**33-KILOVOLT POWER LINE
NASSRIYA, IRAQ**

**SIGIR PA-08-127
JULY 22, 2008**

SUBJECT: Report on Construction of the 33-Kilovolt Power Line, Nassriya, Iraq (Report
Number SIGIR PA-08-127)

Figure 2. 33-kV power line drawing (Courtesy of the USACE)

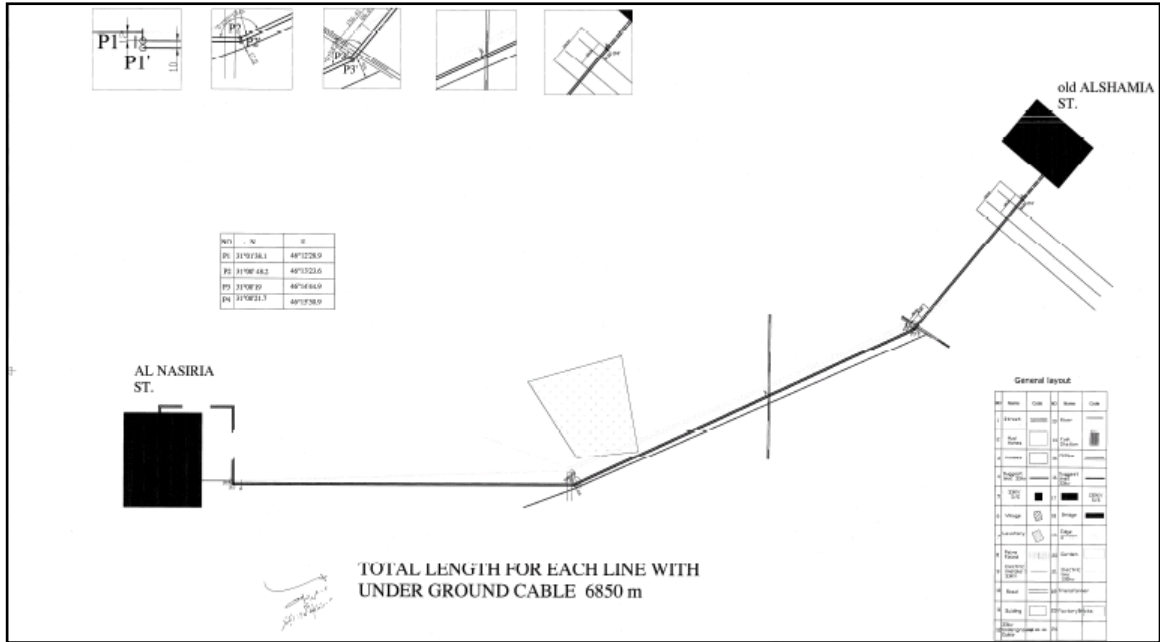
The USACE provided SIGIR with the contractor’s 33-kV power line one page “route” drawing and one profile sheet. The design documents consisted of the route drawing (Figure 2), which provided the total length for each line with underground cable and a profile sheet that determined the height and length between structures. The contractor’s design documents did not provide complete engineering drawings, including construction, civil, mechanical, and electrical, or single line diagrams.

After reviewing the design drawings and specifications supplied, SIGIR determined the design package available was not complete; it lacked sufficient details and did not meet the contract requirements. Specifically, the design documents did not provide any preliminary alignment plans with topographic survey, soil reports, right-of-way plans, construction drawings (which typically includes plan and profile sheets, detail sheets, quantity sheets, and environmental protection plan sheets), structural calculations, foundation calculations, technical specifications, catalog cuts of equipment specified, general design notes with assumptions made, or standard drawings referenced.

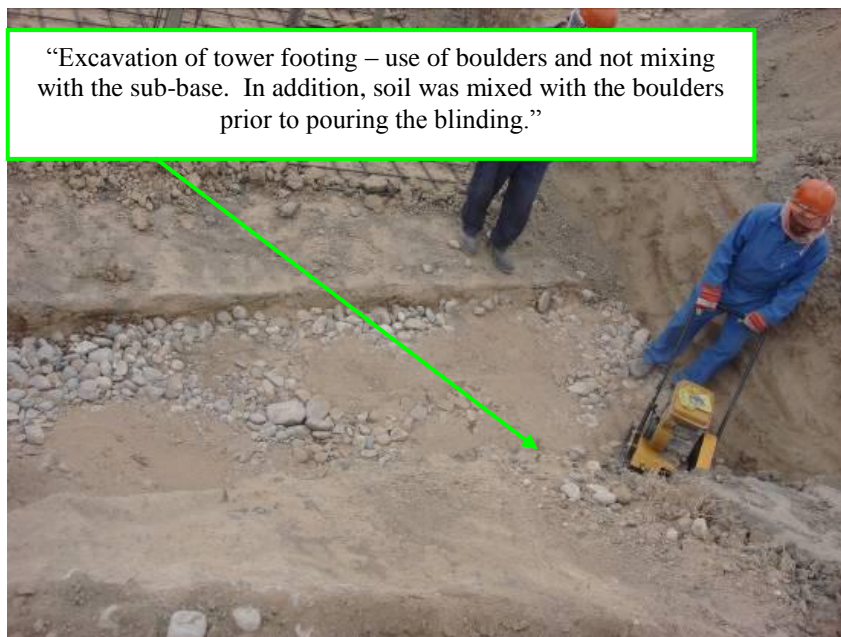
Even though the contract required QC reports, the contractor submitted only one QC e-mail report for 2007 and did not provide any QC reports for 2008. The QC e-mail report did not identify the contractor's daily activities, the labor strength and production of the various trades for the day, or include photographs. The QC e-mail report did not document the activities on site and did not provide meaningful information to the GRS project engineer. In addition, the QC report did not identify any significant construction deficiencies.

SIGIR's review of the contractor's QC plan and report determined its overall QC program was inadequate.
